SEASIDE PARK BAYFRONT FLOODING ADVISORY COMMITTEE

Re: Recommendations, Post RVE Presentation

The committee met with the Mayor and Council in an open public forum/workshop on 18 July 2024 to review and discuss a newly, RVE, proposed fast track bulkhead construction project that would span all of Bayview Avenue. The committee has discussed the proposal and provides the following recommendations:

Barnegat Bay at Route 37 at Seaside Heights NJ - 01408748

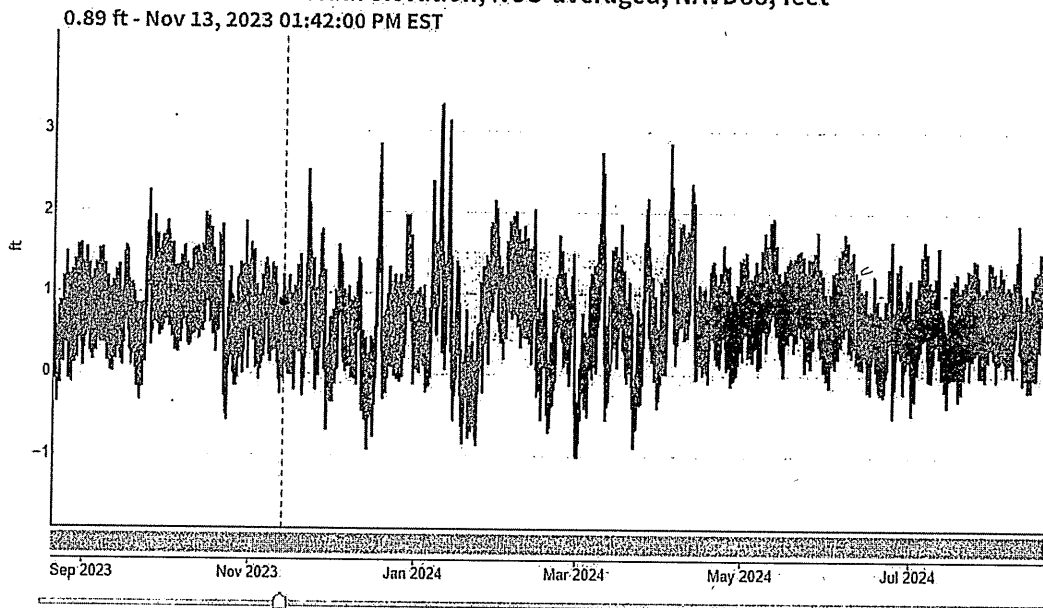
- 4) Situation: The elevation of the proposed barrier (bulkhead) is proposed at 5Ft NAVD 88.
 - a. Recommendation: The proposed elevation 5ft. would place the proposed bulkhead 3 ft. above the current bulkhead at 10th Avenue. This elevation is significant and would greatly impede access to the bayfront. Further discussions on the proposed elevation for the complete barrier is recommended. A review of recent flooding data (<https://waterdata.usgs.gov/monitoring-location/01408748/#parameterCode=72279&period=P7D&showMedian=true>) found the highest tide for the last 12 months was January 10, 2024 was 3.26ft NAVD 88. We believe that flood tide was the highest since 2013. That height is just inches above the existing bulkhead height in some areas. This height also corresponds to the elevation of the Marina bulkheads. The majority of the flood waters come through the storm drain systems and the low areas of reduced or no curb height at times of flood tides. A review of existing information and the gap data (issue#1) is needed by the stakeholders (to include DPW, Borough Marina, Yacht Club, etc..) to conclude an appropriate finished height to be primarily protective of floodwater inundation as well

as preserve access to the bayfront recreational areas.
